From: highways@planning.leics.gov.uk
Sent: 16 January 2025 08:04
To: Sullivan Archer; Planning Folder New
Cc: peter.bedford@leics.gov.uk
Subject: Response To Application Number 24/01145/FUL at Land To The Rear Of Valley View Station Road Desford Leicester
Attachments: Response_2024-6805-04-HCON.pdf
Categories: Sonia

Planning Application Number: 24/01145/FUL

Description of Application: Erection of a bungalow

Substantive Response provided in accordance with article 22(5) of The Town and Country Planning (Development Management Procedure) (England) Order 2015:

Figure 1

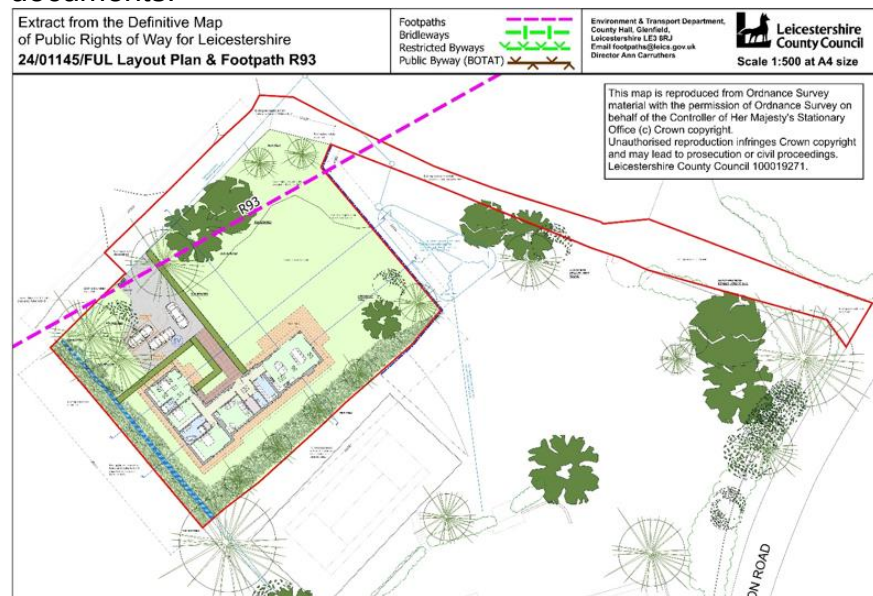
The Applicant needs to be aware that the legal definitive line of PRoW R93 runs through the site, this includes the proposed garden and parking area. Figure 1 below is the 24/01145/FUL Layout Plan overlaid with the legally defined alignment of PRoW R93. The footpath route is through the development site but there is no mention of, nor provision for, the footpath in any application documents.

Later OS maps show that, through this parcel of land, a physical footpath route takes a straighter route approximately along the track labelled 'existing access' on the plans with this application. However physically diverting a footpath without the proper authorisation means the Definitive Map remains unchanged. So, this development will also require diversion of the public footpath by a separate legal order made by the Local Planning Authority, a separate application for which needs to be submitted and also legally confirmed before the development is substantially complete.

Whilst the above would not be a reason for refusal and could be dealt with via a condition, the LHA would advise the Applicant to work towards a resolution as soon as possible. For further information the Applicant should contact the PRoW team via footpaths@leics.gov.uk as a matter of urgency.

Figure 2

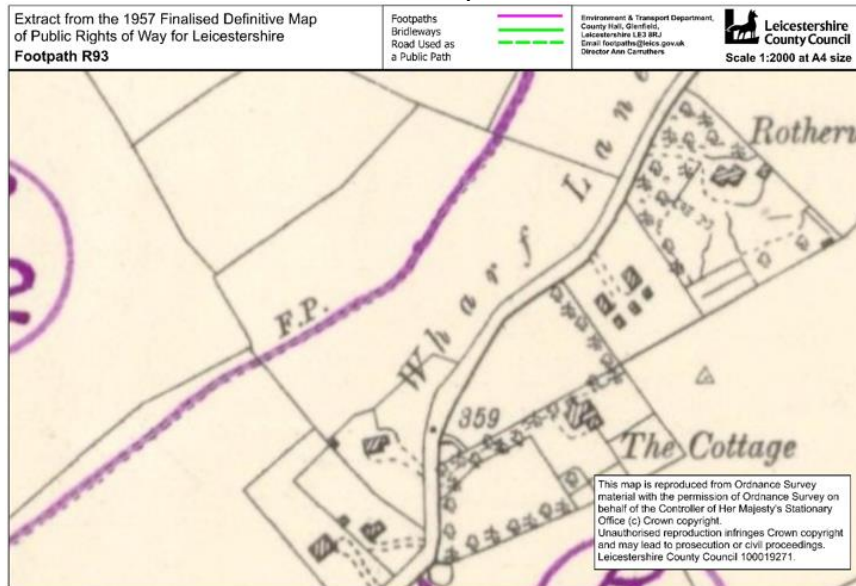
Figure 2 below is from the 1957 Finalised Definitive Map based on the OS 1928 map (when Station Road was known as Wharf Lane).
